TUBULAR GIRDER BRIDGES.

WILLIAM FAIRBAIRN, M. INST. C.E.

No. 826.—“On Tubular Girder Bridges.”*
By William Fairbairn, M. Inst. C. E.

DOUBTS having been entertained as to the ultimate security of the Torksey Bridge, over the River Trent, the Author has investigated the subject with the utmost care and attention.

Fig. 1.

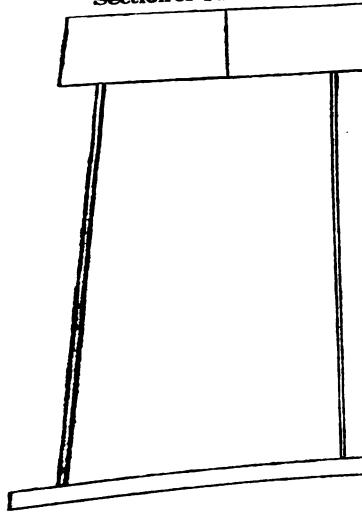
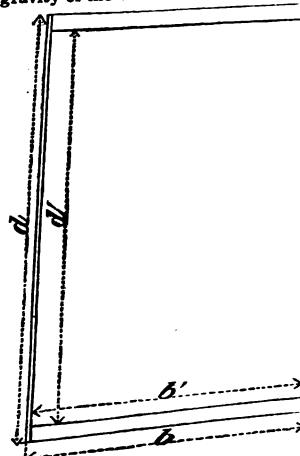
Section of Tube nearly equivalent in strength, the thickness of the bottom and sides being equal to those in the former ; and the top of equal area of section to that of the cells in the former, and placed at the height of the centre of gravity of the cells.

Fig. 3.
Diagram of Deflection.

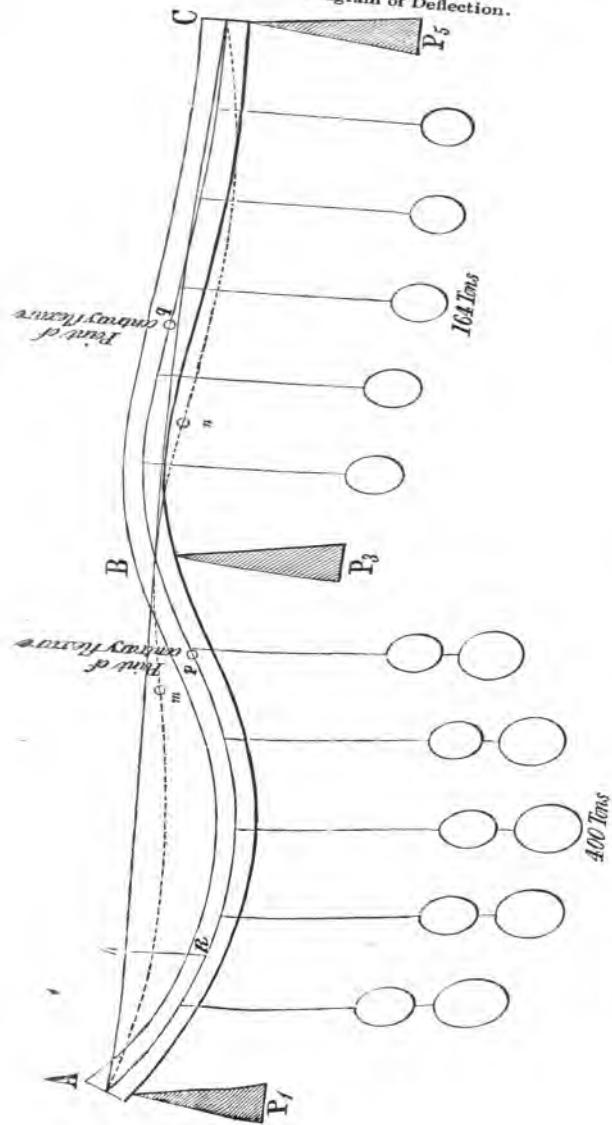
The diagram (Fig. 3, page 25) had been prepared for the purpose of showing the effect of the continuity of the girder, the dotted line showing the curve of deflection, due to weighting the two openings equally with the weight of the structure itself alone ; the full line showing the deflection, due to an additional load of two trains of locomotives upon one span. The latter experiment proved, that the distance from the point of contrary flexure to the centre pier was less than 25 feet, causing a practical reduction of the span from 130 feet to about 105 feet, and adding at least one-fourth to the strength of the bridge. Now any principle that added one-fourth to the strength of a bridge was, he considered, too important to be so lightly passed over ; added to which, he thought the saving of cost in the construction of the work was an important additional consideration.

The dotted line represents the position of the girder as deflected by its own weight only, viz., $16\frac{1}{2}$ tons distributed over each span.
